<b>Date</b>	March 3, 2011
<b>To</b>	Greg Angelo – Director of Real Property Management and Development
<b>From</b>	Chip Hazen – ADA Compliance Officer
<b>Subject</b>	ADA Evaluation of Union Station

On February 28, 2011, I completed a quick walk through of Union Station. Observed were the common general public areas such as the tunnels to the track platforms, rest room lobby area, Amtrak lobby area, the two outside patios, and the parking lot. From the observations, the ADA issues fall in three categories: safety, physical accommodations, and signage.

No cover on electrical outlet on ramp serving Tracks 11 and 12.

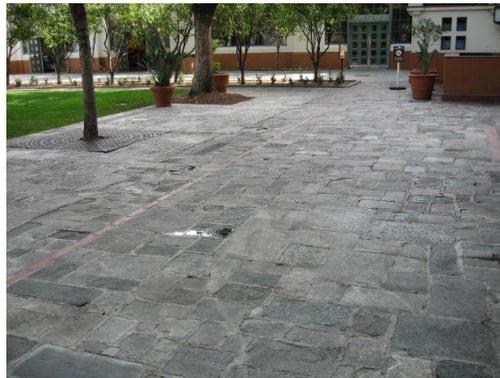
On the ramp leading to Tracks 11 and 12, the cover for the electrical outlet is missing. This could pose a safety hazard for persons with vision impairments, riders in wheelchairs, and small kids.

Handrails do not extend beyond the top of the ramp and does not extend at the bottom of the ramp.

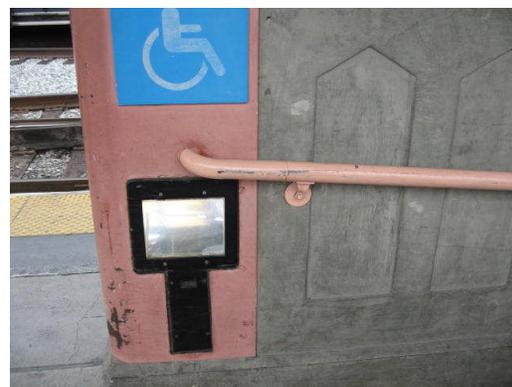
The ramps to the tracks on the north side of the tunnel have slopes ranging from 7.3% to 7.6%, which is within the ADA required slope maximum of 8.33%. However, there are no resting areas along the ramp (the ADAAG requires one every 30' to 40'), and the handrails do not comply with the ADAAG requirements.

Platform with 2” gap between the truncated domes and the “edge” of the platform.

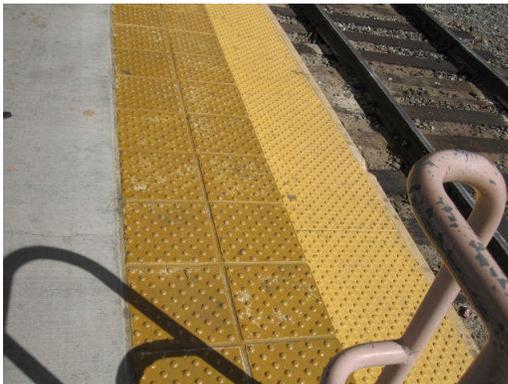
The other platforms, which are used by Metrolink, have a two inch gap between the truncated domes and the edge of the platform. The ADA requires the following:

810.5.2 Detectable Warnings. Platform boarding edges not protected by platform screens or guards shall have detectable warnings complying with 705 along the full length of the public use area of the platform.

705.2 Platform Edges. Detectable warning surfaces at platform boarding edges shall be 24 inches (610 mm) wide and shall extend the full length of the public use areas of the platform.

Color difference

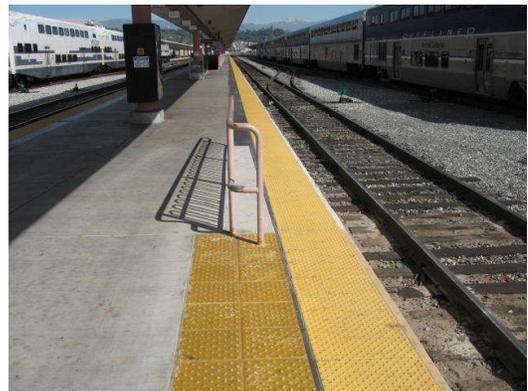
The color of the truncated domes is a State of California requirement. The color that all California transportation agencies must conform to is Federal Color No. 33538 of Standard No. 595B. The high platform loading area uses a different color truncated dome than is the standard. The contrast between the two colors can be seen in the following pictures.

Long shot of disabled drop-off zone

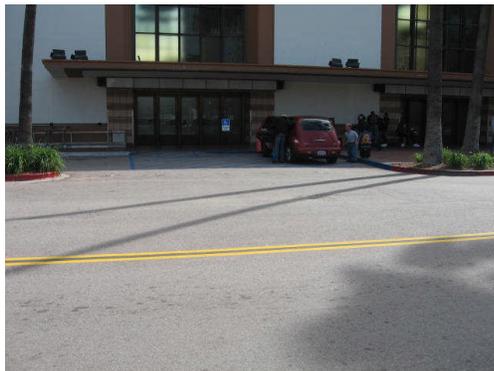
In 2003 the Federal Transit Administration made a finding that Union Station provided designated drop-off locations for the general public but not for persons with disabilities, as required by both state and federal accessibility requirements. Therefore, Union Station developed an area for dropping off persons with disabilities; however, that area does not conform to the ADA specifications, which are as follows:

The ramp must be made of concrete, cannot be part of the loading zone, and ramp is not long enough, and there is no space for parallel parking

503.2 Vehicle Pull-Up Space. Passenger loading zones shall provide a vehicular pull-up space 96 inches (2440 mm) wide minimum and 20 feet (6100 mm) long minimum.

503.3 Access Aisle. Passenger loading zones shall provide access aisles complying with 503 adjacent to the vehicle pull-up space. Access aisles shall adjoin an accessible route and shall not overlap the vehicular way.

503.3.1 Width. Access aisles serving vehicle pull-up spaces shall be 60 inches (1525 mm) wide minimum.

503.3.2 Length. Access aisles shall extend the full length of the vehicle pull-up spaces they serve.

503.3.3 Marking. Access aisles shall be marked so as to discourage parking in them.
